# HIGHWAY WORK PROPOSAL

<u>COUNTY</u>	<u>STATE PROJECT</u>	<u>FEDERAL</u>	<u>PROJECT DESCRIPTION</u>	<u>HIGHWAY</u>
Dane	1007-12-79	WISC 2020313	Illinois State Line - Madison; USH 12/18 Intchg/Core SB	IH 039
Dane	1007-12-80	WISC 2020314	Illinois State Line - Madison; USH 12/18 Intchg/Core NB/Final Work	IH 039
Rock	1008-10-70	WISC 2020315	Illinois State Line - Madison; Safety Rest Area 22	IH 039

## ADDENDUM REQUIRED ATTACHED AT BACK

Addendum No. 01  
ID 1007-12-79  
Revised Sheet 12  
June 2, 2020

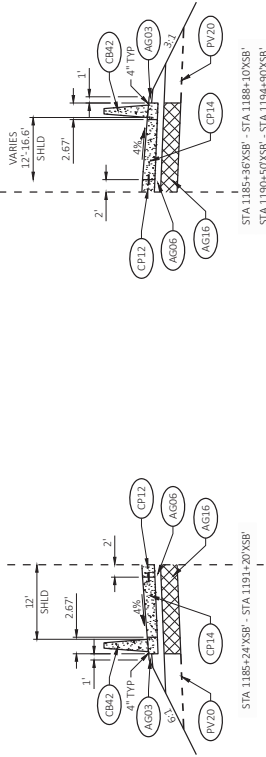
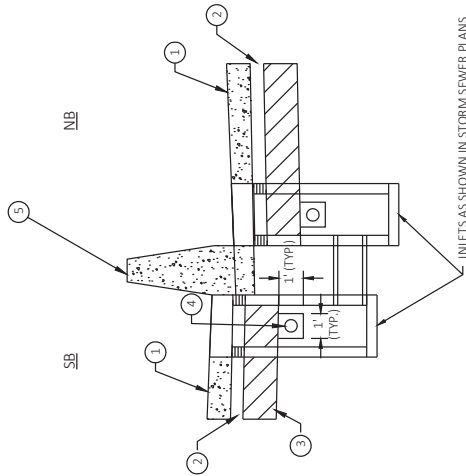
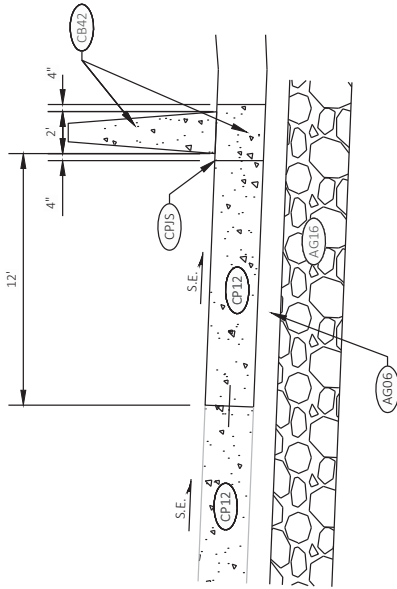
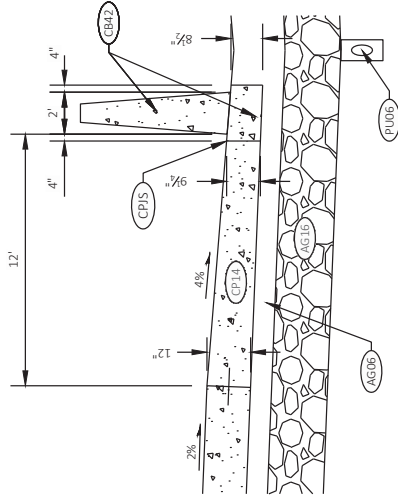
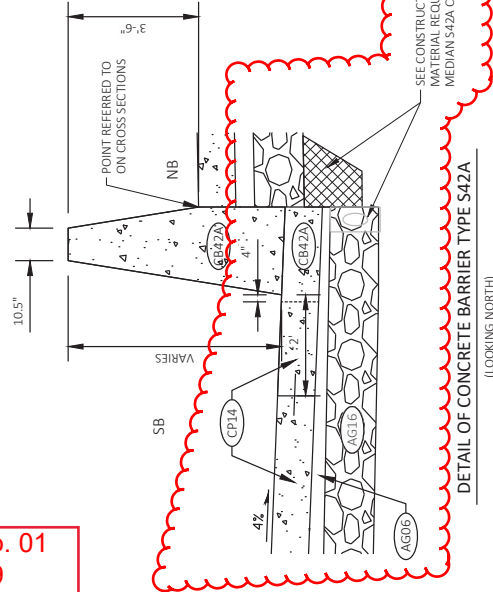
<b>Revised Plan Sheets 1007-12-79</b>	
Plan Sheet	Plan Sheet Title (brief description of changes to sheet)
12	Typical Sections - Finished (updated typical to show the location for longitudinal saw cut)
25	Construction Details (updated the detail for Concrete Barrier Type S42A to show the joint location and to define the concrete pavement pay limits)
322	Miscellaneous Quantities (increased undistributed quantity for 649.0760 Temporary Marking Raised Pavement Marker Type I)
324	Miscellaneous Quantities (increased undistributed quantity for 628.7560 Tracking Pads, added new item 604.9010.S Slope Paving Repair Crushed Aggregate)

Addendum No. 01  
ID 1007-12-80  
Revised Sheet 37  
June 2, 2020

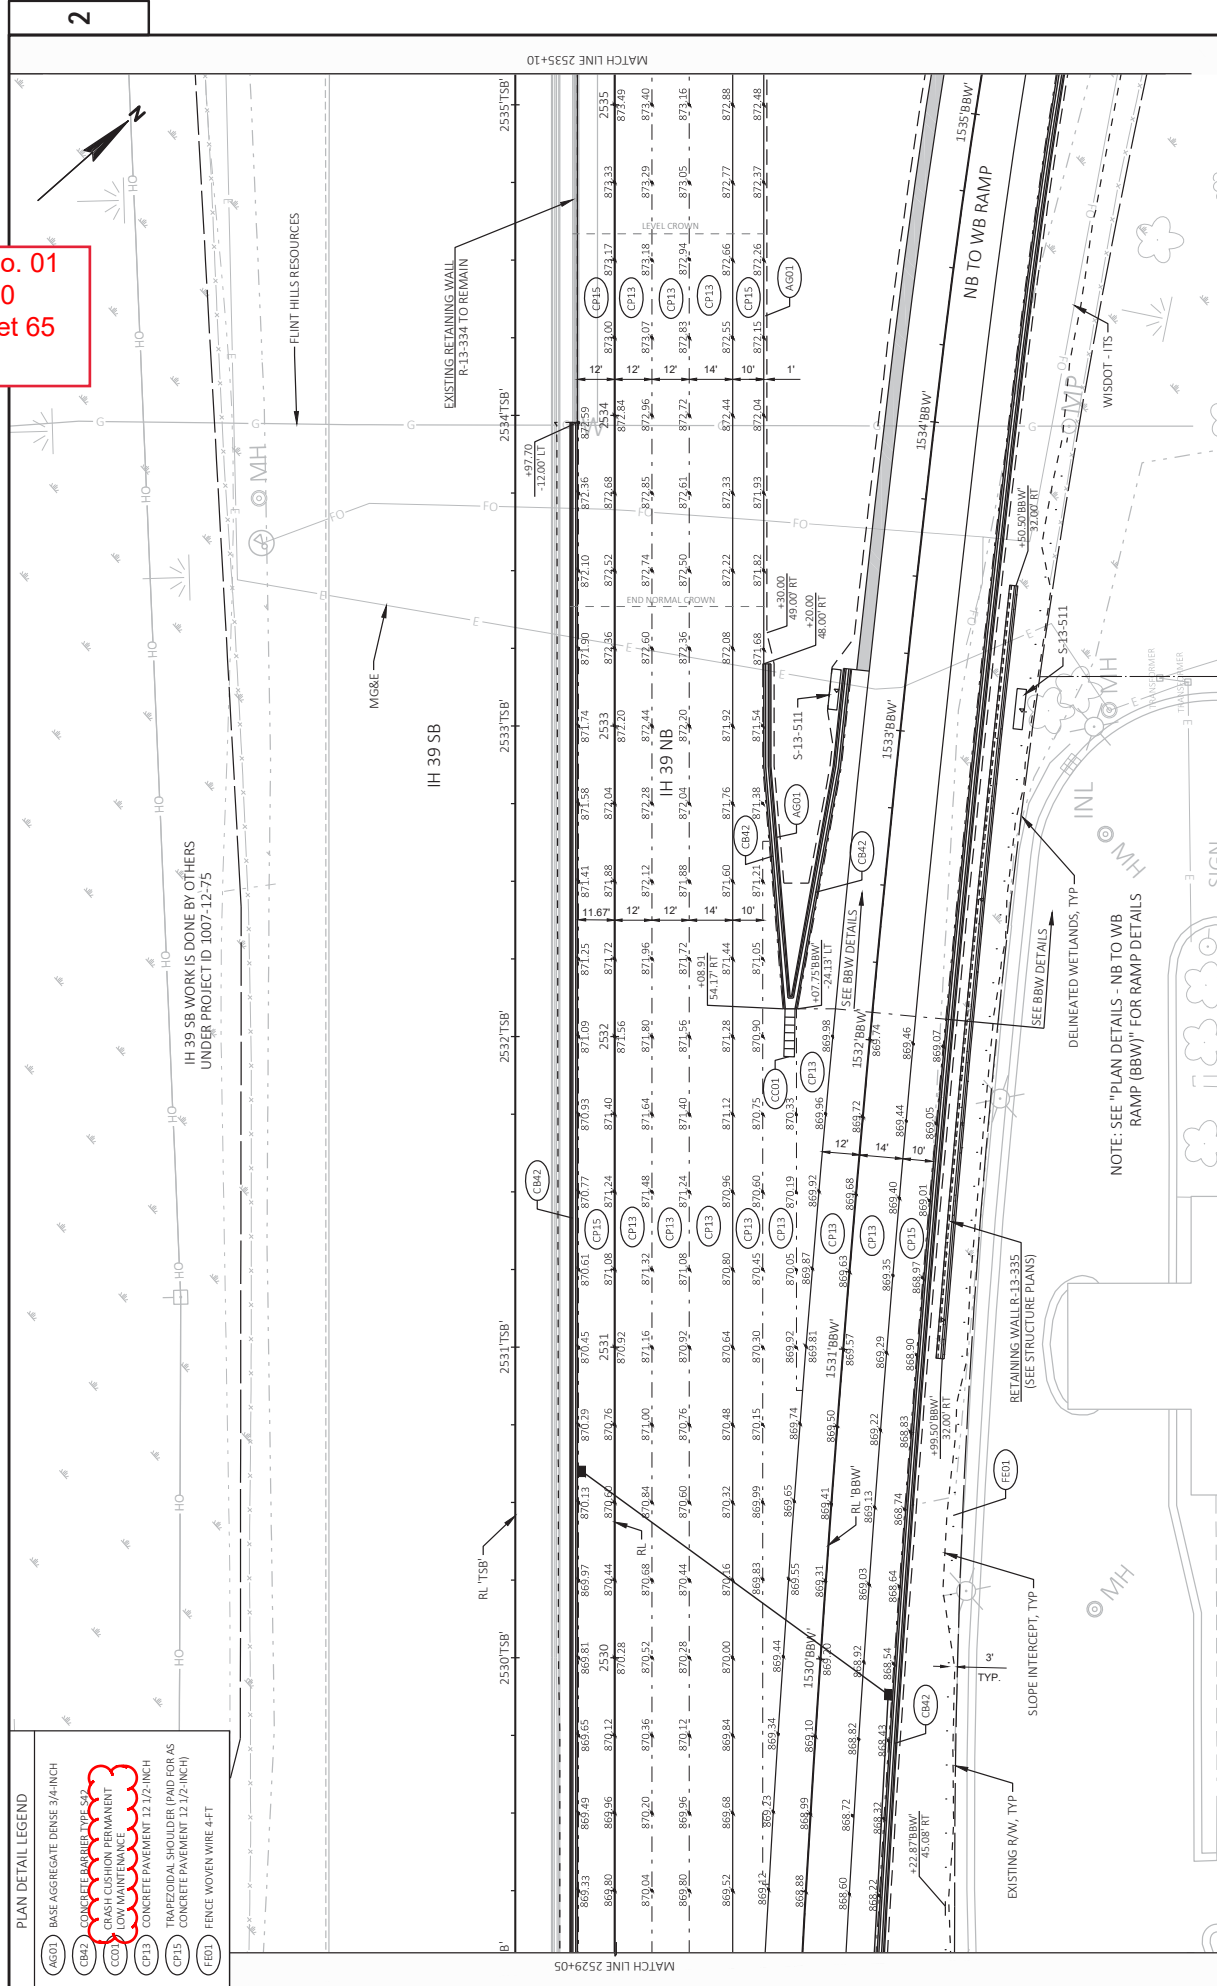
<b>Revised Plan Sheets 1007-12-80</b>	
Plan Sheet	Plan Sheet Title (brief description of changes to sheet)
37	Construction Details (updated the detail for Concrete Barrier Type S42A to show the joint location and to define the concrete pavement pay limits)
58	Removal Plan (revised note from Abandoning Culvert Pipe to Abandoning Sewer)
65	Plan Details (revised legend from Crash Cushions Permanent to Crash Cushions Permanent Low Maintenance)
83	Plan Details (revised legend from Crash Cushions Permanent to Crash Cushions Permanent Low Maintenance)
152	Storm Sewer (revised note for Manhole Covers Type J to Manhole Covers Type J Special)
202	Traffic Control (removed a unnecessary note about extending and removing a pipe)
305	Miscellaneous Quantities (deleted 204.0270 Abandoning Culvert Pipe, added new item 204.0291.S Abandoning Sewer)
308	Miscellaneous Quantities (revised quantities for 415.0120 Concrete Pavement 12-Inch and 415.0125 Concrete Pavement 12.5-Inch)
